Vietnam Veterans Memorial Center

NCPG Revised Concept Submission April 3, 2009 | POLSHEK PARTNERSHIP ARCHITECTS

I. National Capital Planning Commission ACTION & COMMENTS

NCPC File No. 6597

ADDITIONAL OPPORTUNITIES FOR PEDESTRIAN CROSSING

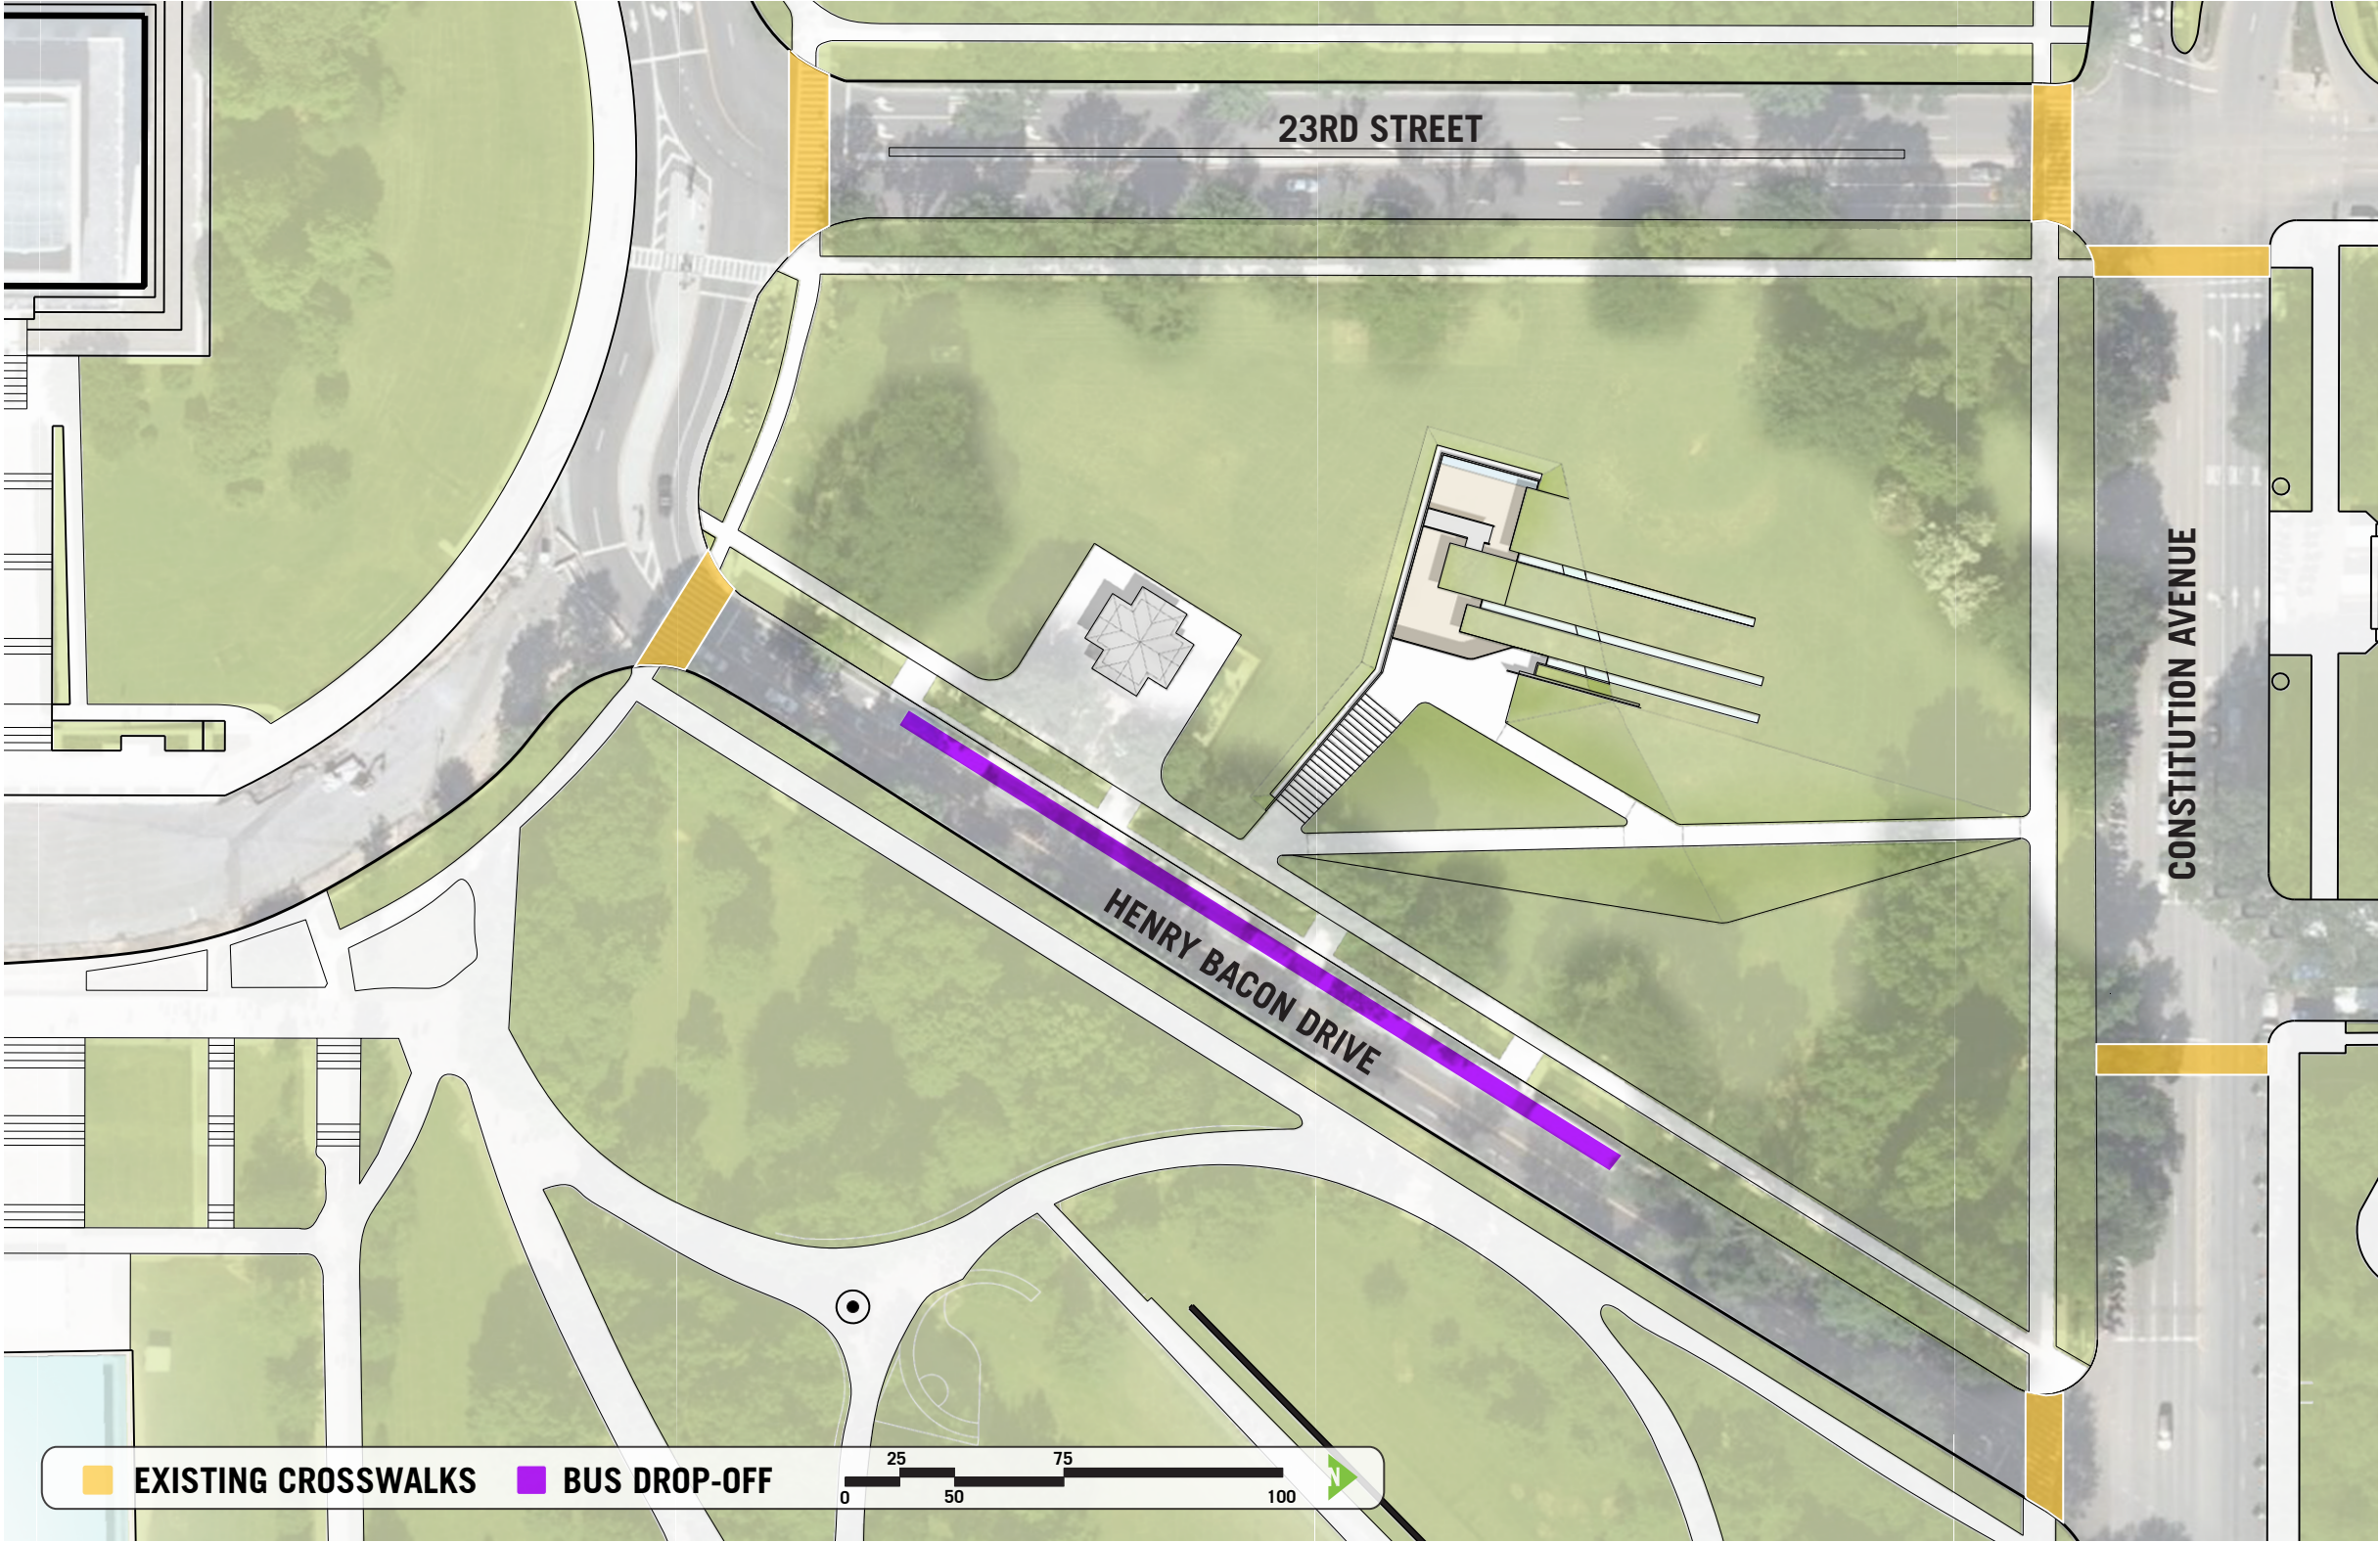
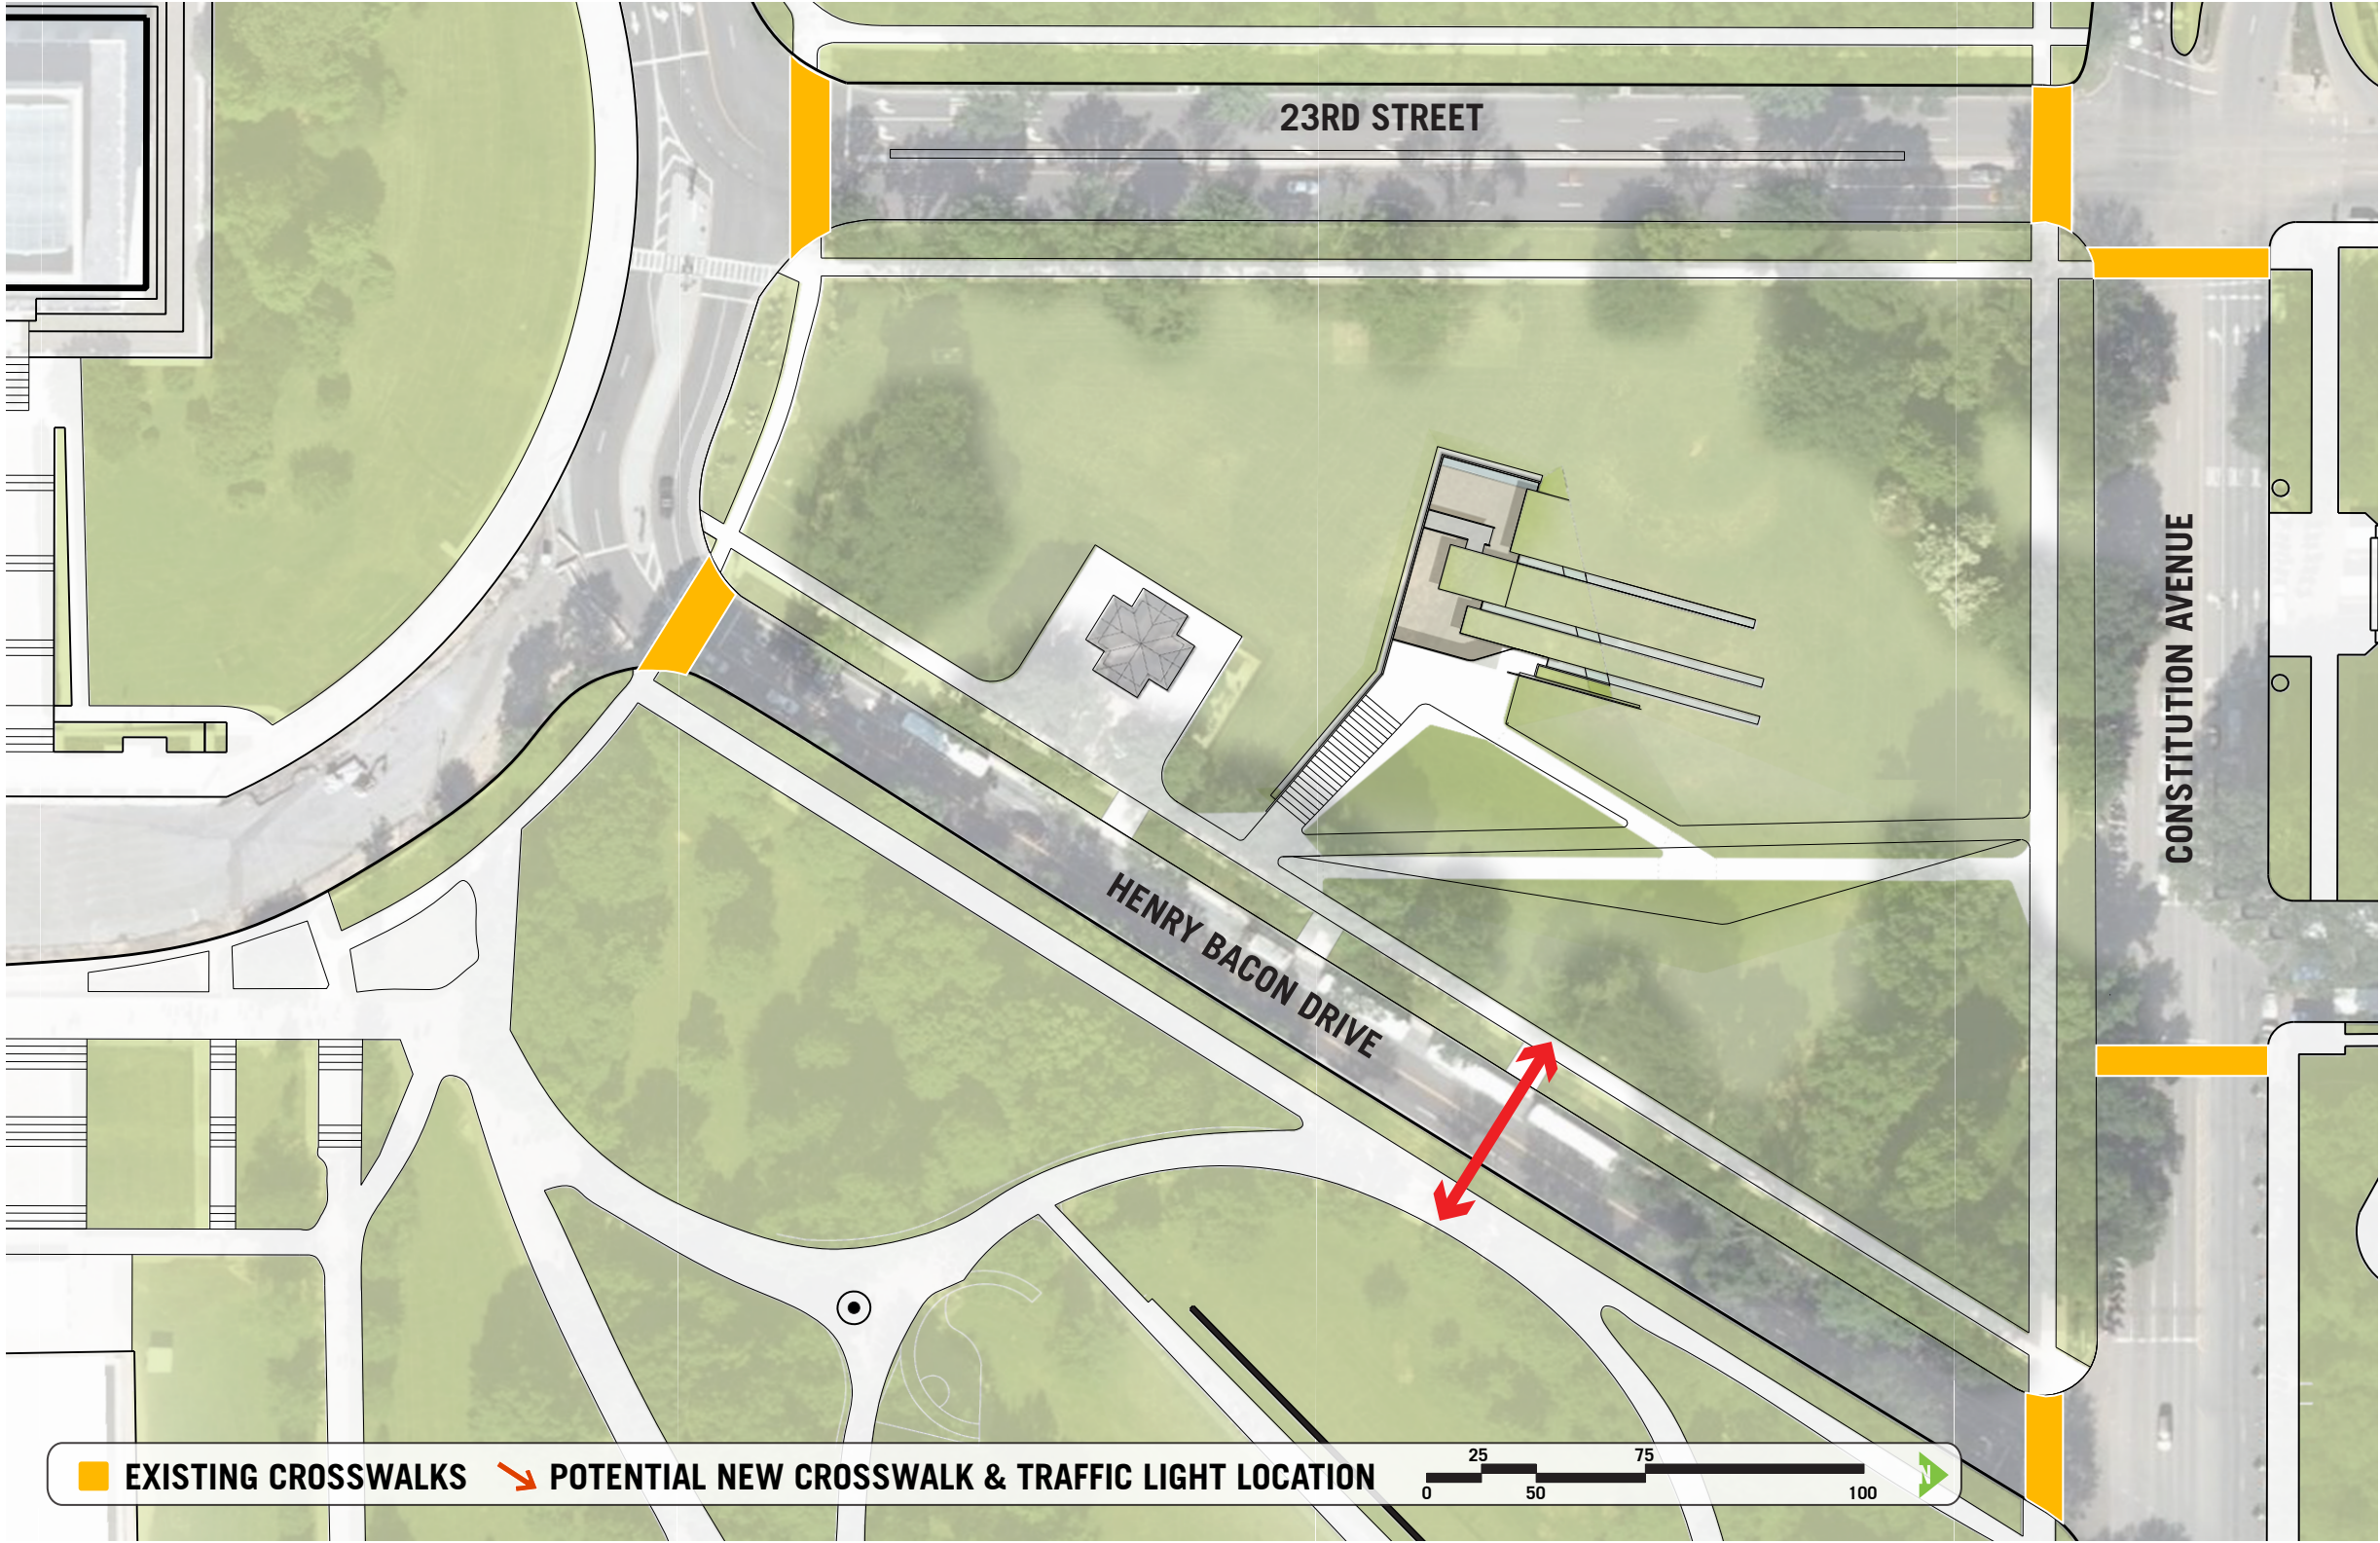
- “The Visitor Center’s associated pedestrian street crossing points will be designed to address traffic impacts effectively and to protect pedestrian safety.” (#10)

The applicant has not yet designed the project’s pedestrian crossing points. Project pedestrian crossing points should be designed to meet this mitigation action.

- A. Two diagrams regarding street crossing, one depicting the existing crosswalk locations and the other suggesting the possible location of a midblock street crossing on Henry Bacon Drive. The design team believes that the issue of a midblock street crossing should be ultimately addressed through the National Park Service in discussion with the DC Department of Transportation.

CRITICAL ROOT ZONE

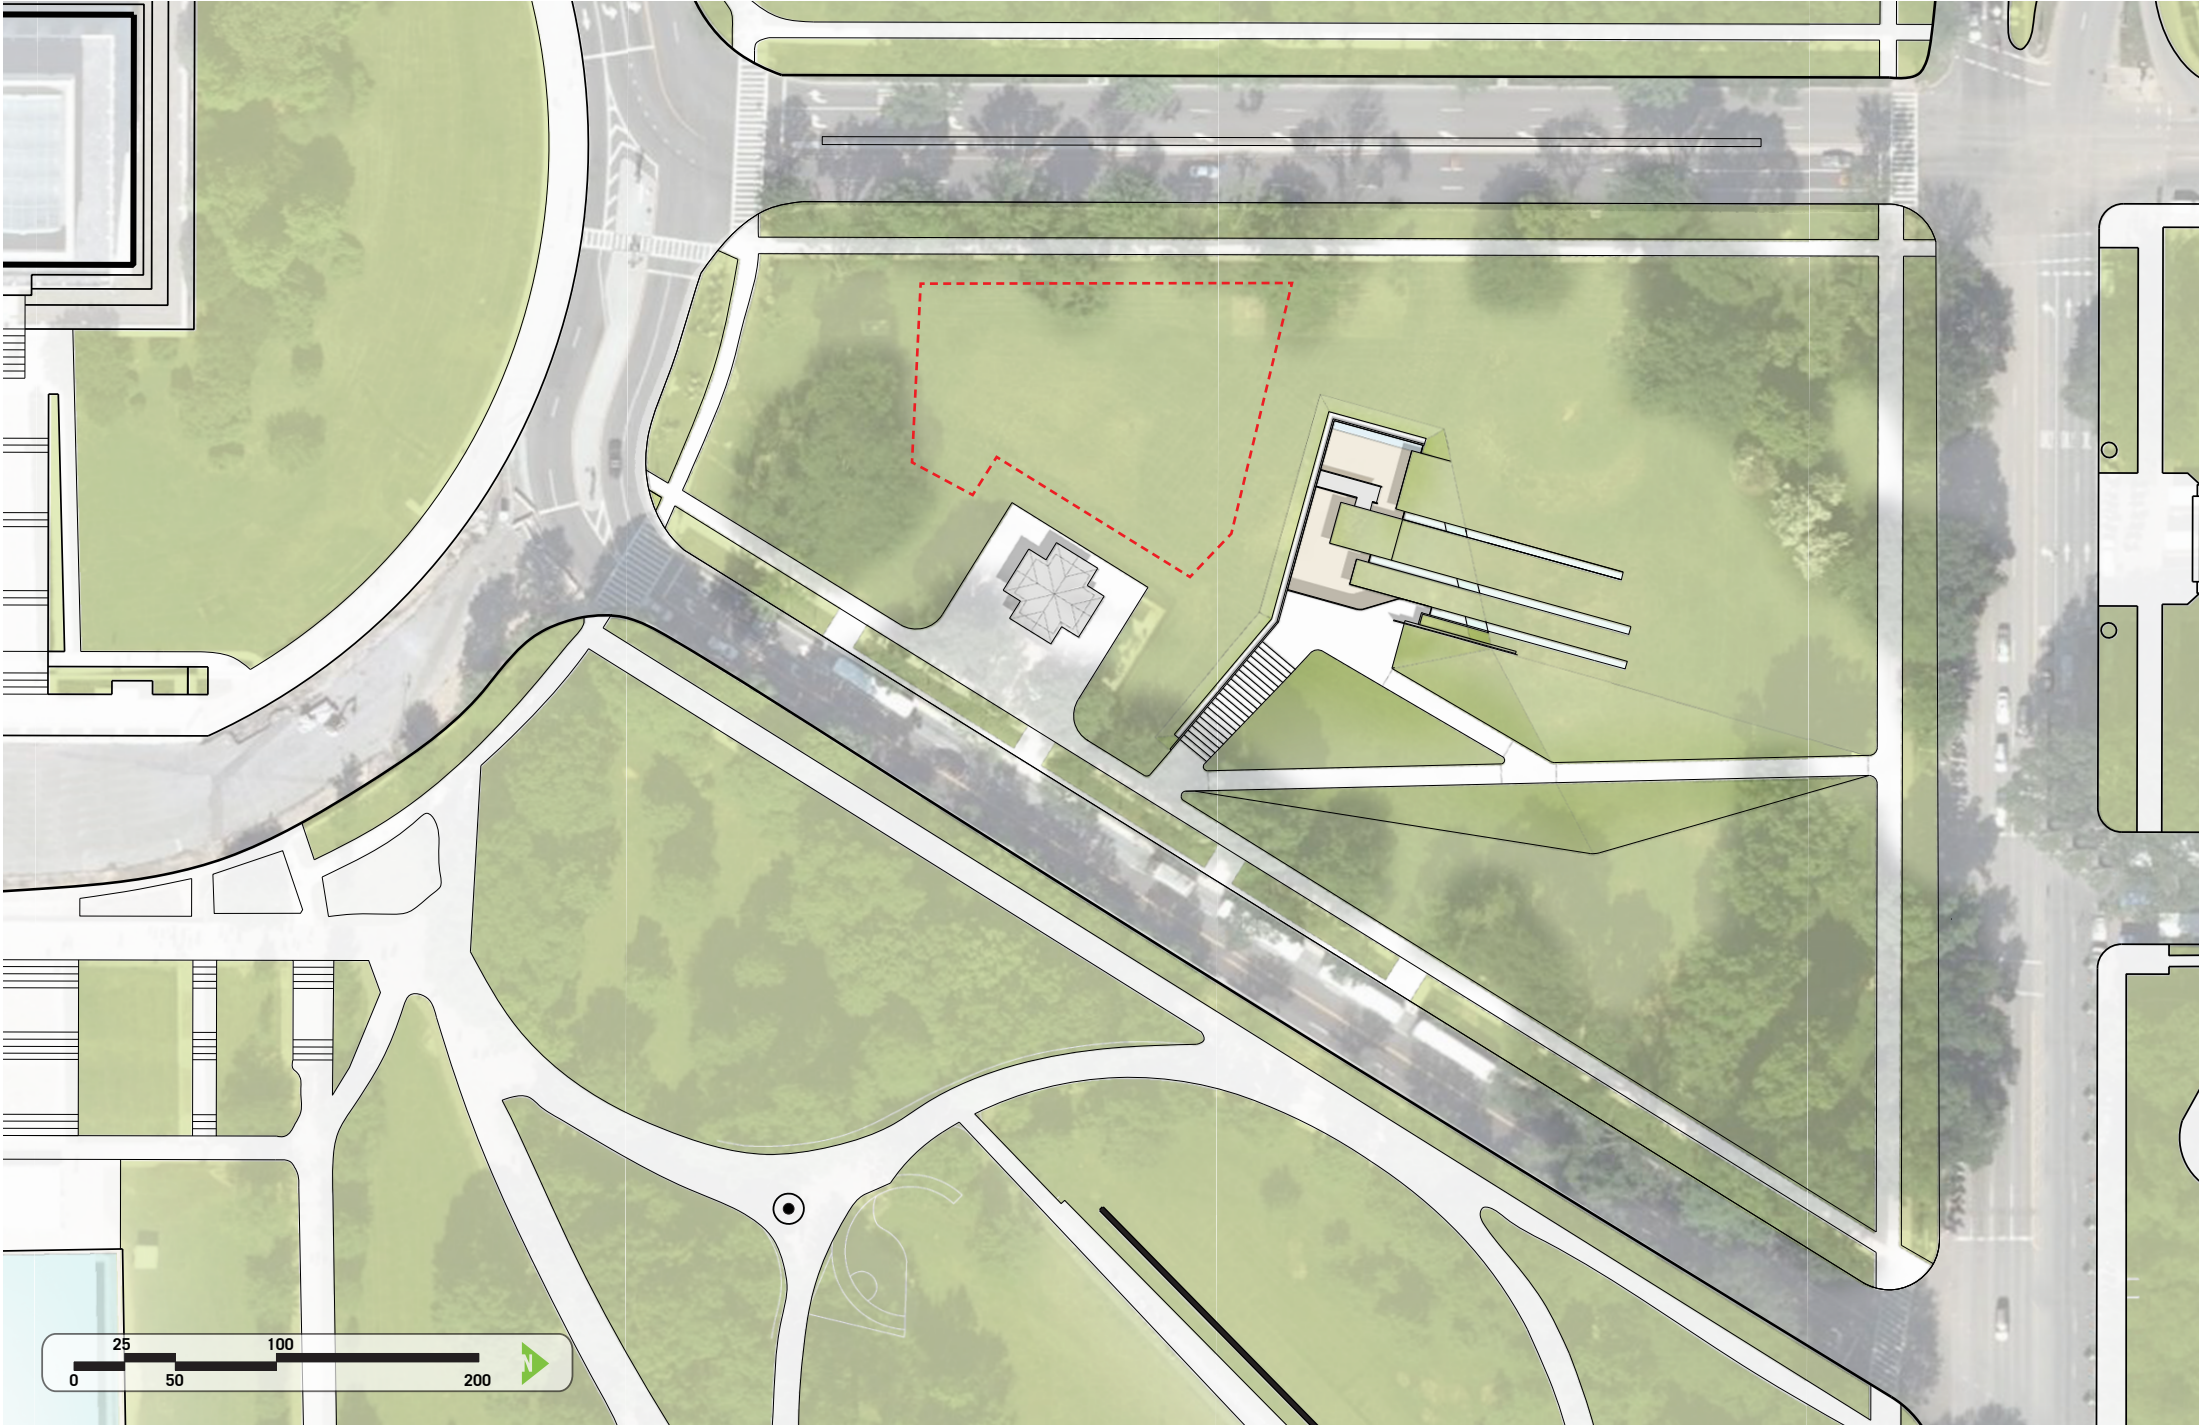
- “The Visitor Center will be constructed only on the portion of the site that lies outside of the critical root zone of existing elm trees. The applicant will develop a tree protection plan to protect and preserve the trees both during and after construction in accordance with standard design and construction procedures.” (#11)

The applicant has not yet demonstrated the actual location of the critical root zone of existing elm trees. Project materials should include a survey of the critical root zone to demonstrate how the project will meet this mitigation action.

- B. A diagram depicting the perimeter tree root zone, the approach ramps/stairs and the overall building footprint. A technical survey of the site, including the tree root zone per the National Park Service horticultural definition, is currently underway. The NPS specification of the critical root zone as a multiple of dbh and a sample specification describing tree protection standards are also included.
